QUAD-CITIES
DPR-29

ATTACHMENT D
SIGNIFICANT HAZARDS CONSIDERATION

DRESDEN STATION UNITS 2 & 3
QUAD CITIES STATION UNITS 1 & 2
BACKFILL MODIFICATION

FIGURE 1

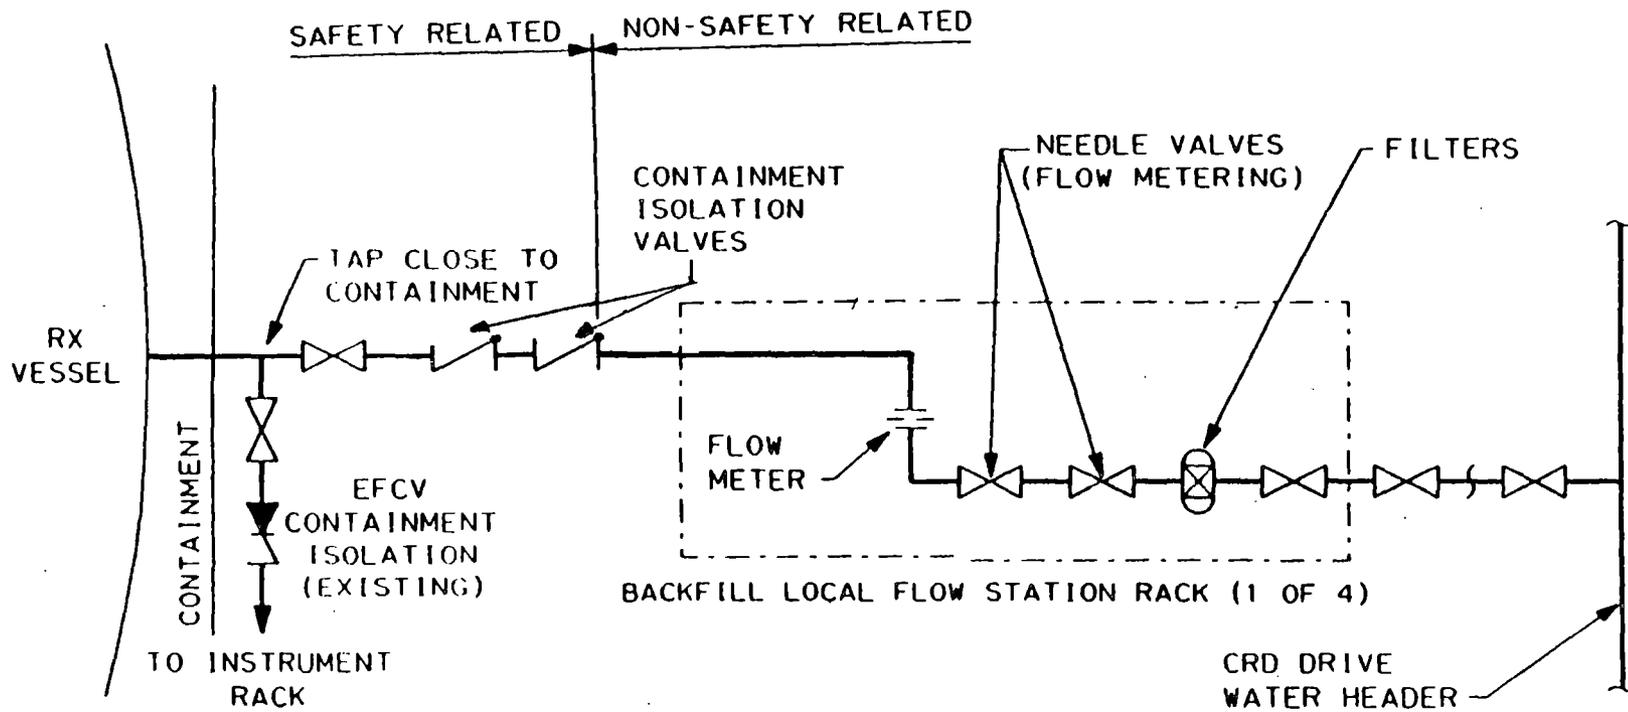
The proposed modifications (and proposed Technical Specification amendments) add reference leg backfill instrument lines and check valves to the reactor vessel level instrumentation. The proposed modifications will eliminate the phenomenon described in IEB 93-03 (dissolved gases in the RVLIS piping may produce uncertainties in the level instrumentation during RPV depressurization) by providing degassed Control Rod Drive (CRD) water to the RVLIS reference leg piping. The proposed design ensures that a continuous column of water, free of non-condensable gases is maintained in the RVLIS reference leg piping. As such, the proposed modifications do not affect any accident precursors or initiators. Therefore the proposed modifications for the reference leg backfill instrument lines do not increase the probability of any previously evaluated accidents for Dresden Station and Quad Cities Station.

The proposed modification connects the non-safety-related CRD system to each safety-related division of RPV instrumentation and Feedwater Level Control System. The backfill check valves will eliminate the potential for reference leg leakage if CRD piping integrity is lost. These check valves are classified as safety-related and will be maintained and controlled such that overall plant safety is maintained. The addition of the reference leg backfill check valves to the Technical Specifications does not create the possibility of a new or different kind of accident for Dresden Station or Quad Cities Station.
